REMARKS

This is in response to the non-final Official Action currently outstanding with regard to the above-identified application.

Applicant: N. Yasunishi, et al
U.S.S.N.: 09/748,502
Page 22

CONVENTIONAL
ART**FIG. 14A****FIG. 14B**

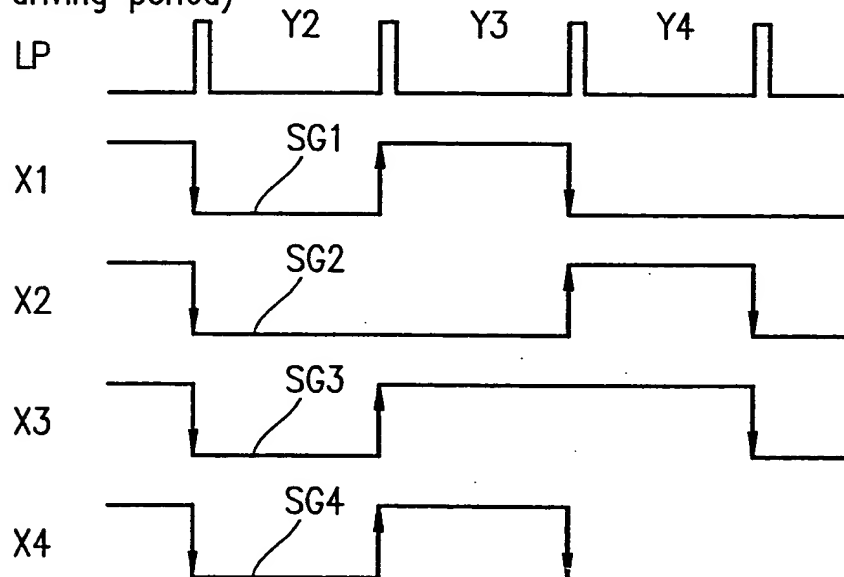
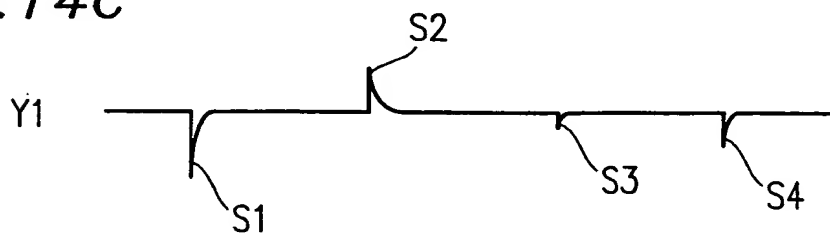
3. Provided Applicants with a Notice of References Cited (Form PTO-892) along with copies of the cited references;
4. Indicated that the drawings filed as part of this application are objected to on the basis that Figures 14A, 14B, 14C and 15 should be designated by a legend such as - PRIOR ART --, since only that which is old is illustrated therein - **Applicant respectfully requests that the foregoing Request for Drawing Change Approval be granted and that the new formal drawings submitted concurrently herewith be entered into this case in substitution for the corresponding sheets of drawing as originally filed in response to the Examiner's objection;**

With respect to item 4, Applicants respectfully call the Examiner's attention to the foregoing Request for Drawing Change Approval, the attached photocopies of Figs. 14 A, 14B, 14c and 15 of the present application whereon the proposed addition of the legend -- CONVENTIONAL ART -- is shown in red, and to the concurrently filed new set of formal drawings that include the changes proposed by Applicants. In the above regard, Applicants respectfully submit that since the specification characterizes the showings of Figs. 14A, 14B, 14C and 15 as "conventional", as opposed to admitting the statutory prior art status thereof, the proposed legend -- CONVENTIONAL ART -- is appropriate in the present circumstances to remove the basis of the Examiner's objection to the drawings. A decision so holding in response to this communication is respectfully requested.
